Filer School District - Auditorium Renovation- <b>REVISED with ADD NO. 2</b>				
Bids to Starr Corporation by October 3, 2025 at 2:00PM				
Bid Package No.	Package Description	Spec Section	Description	Additional Comments: All items include material, labor, and equipment for installation, unless noted otherwise.
<b>BP-01 Rough Carpentry</b>				
01	Rough Carpentry	Division 1	General Requirements	All sections to be included in their entirety.
01	Rough Carpentry	017000	Selective Demolition	Demo as needed to install window and millwork in sound room.
01	Rough Carpentry	061000	Rough Carpentry	Include in its entirety. <b>Includes supply and installation of the windows in the soundbooth.</b>
01	Rough Carpentry	062000	Finish Carpentry	Include in its entirety.
01	Rough Carpentry	641000	Casework	Include in its entirety.
01	Rough Carpentry	72000	Insulation	Include in its entirety.
01	Rough Carpentry	079000	Joint Sealants	As applies to this scope of work.

## Addendum No. 2

PROJECT: Filer Auditorium  
Date: September 25, 2024

1 DEMO FLOOR PLAN  
 1/4" = 1'-0"

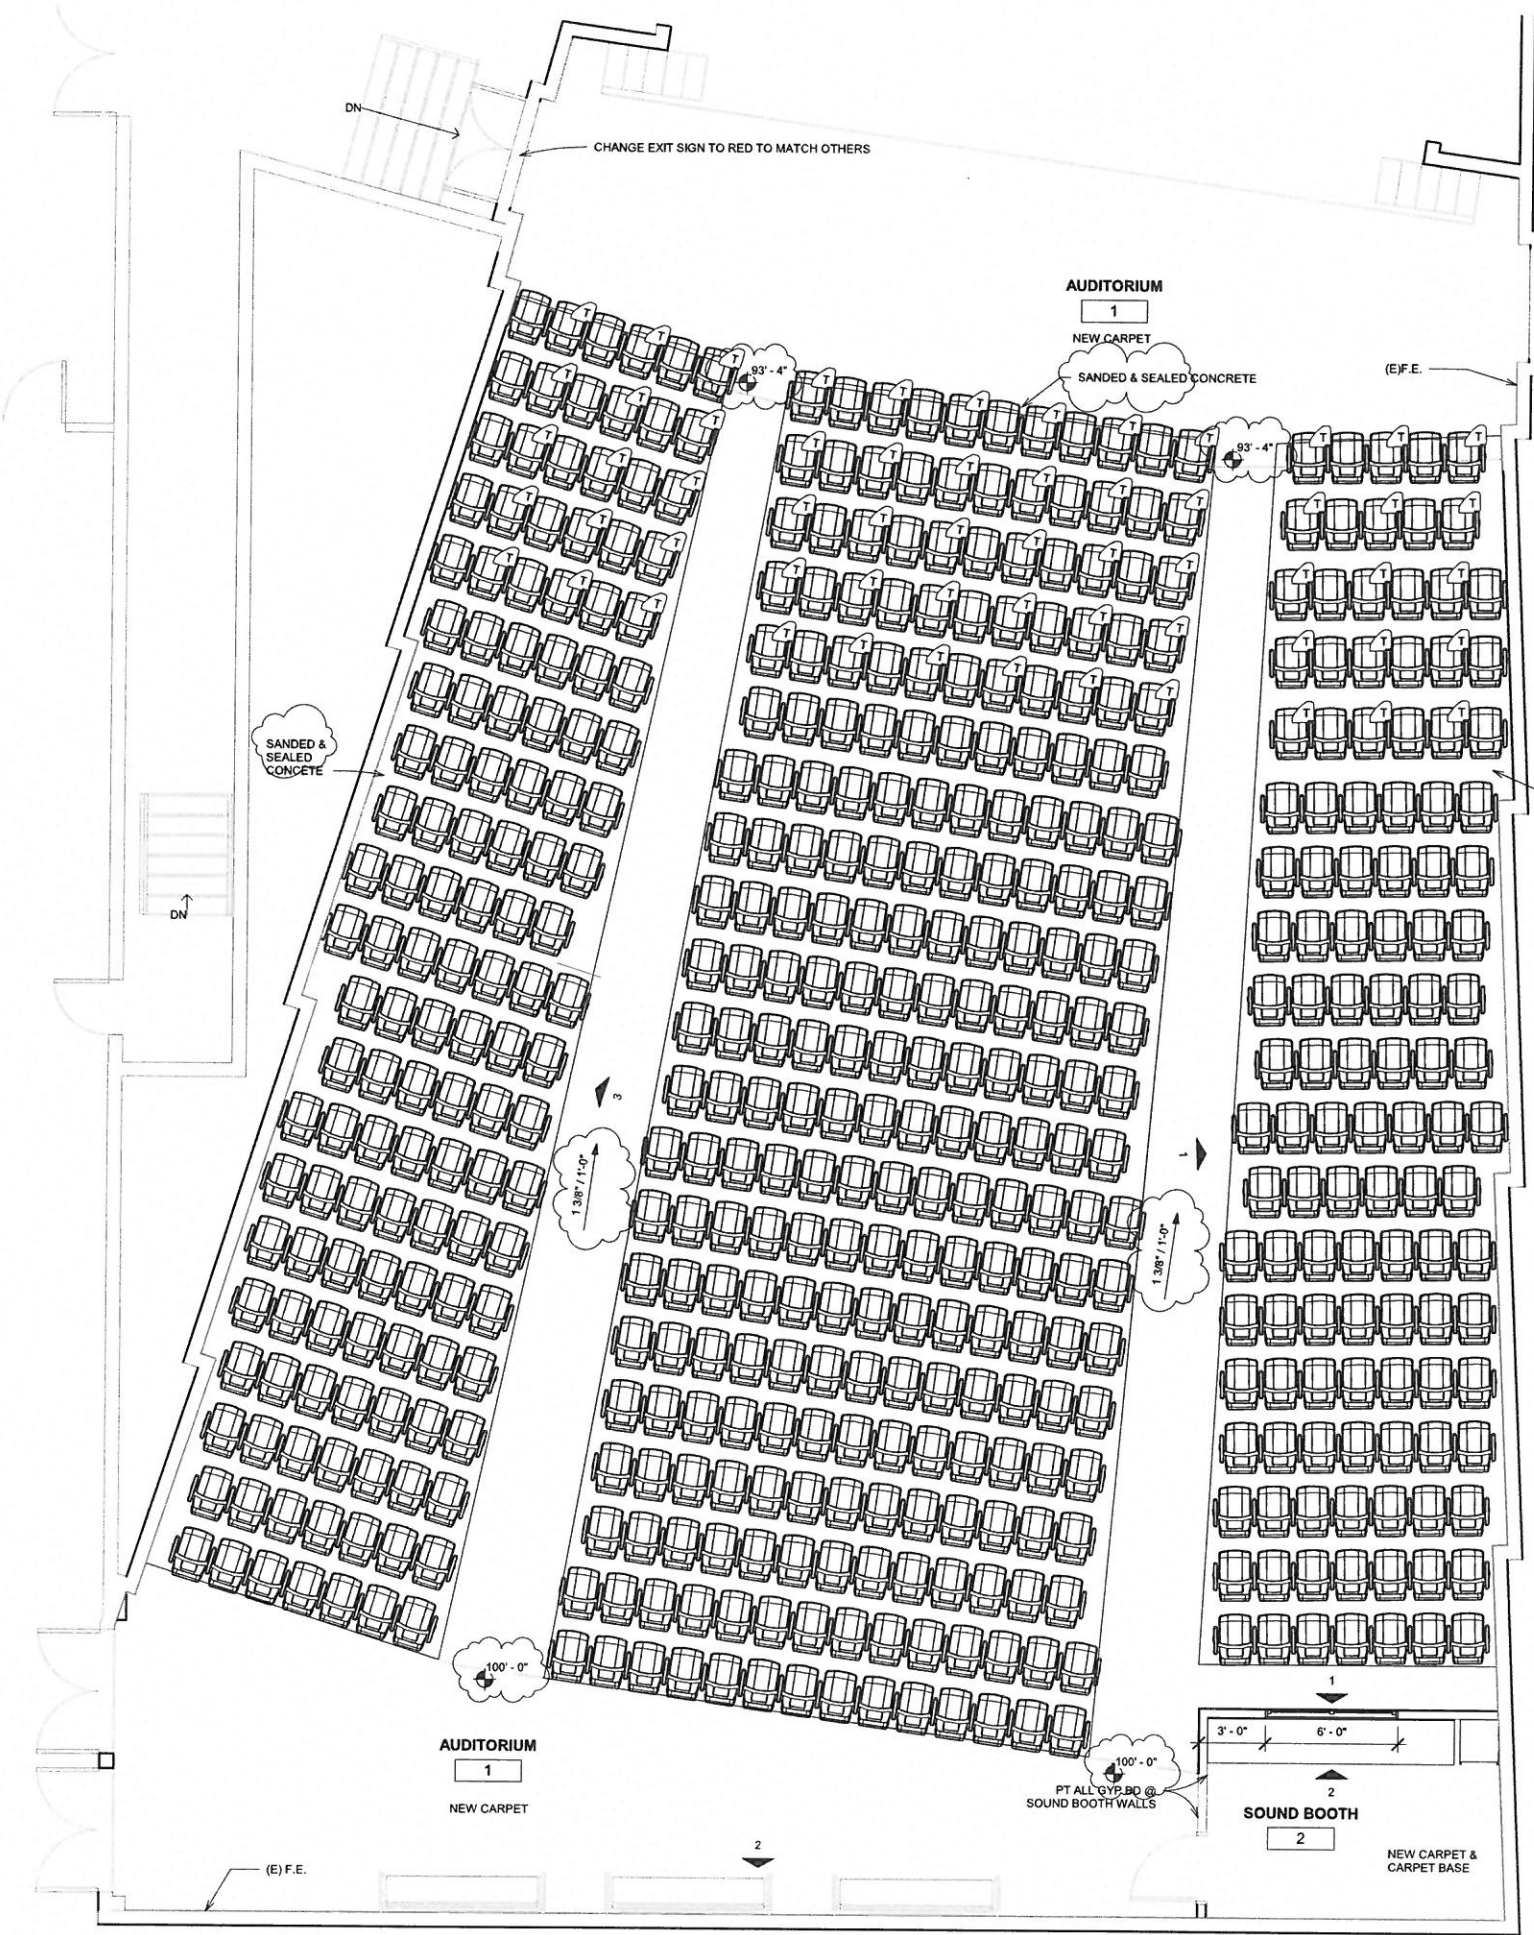
1. Polished concrete shall be removed and exposed concrete shall be sanded and sealed.
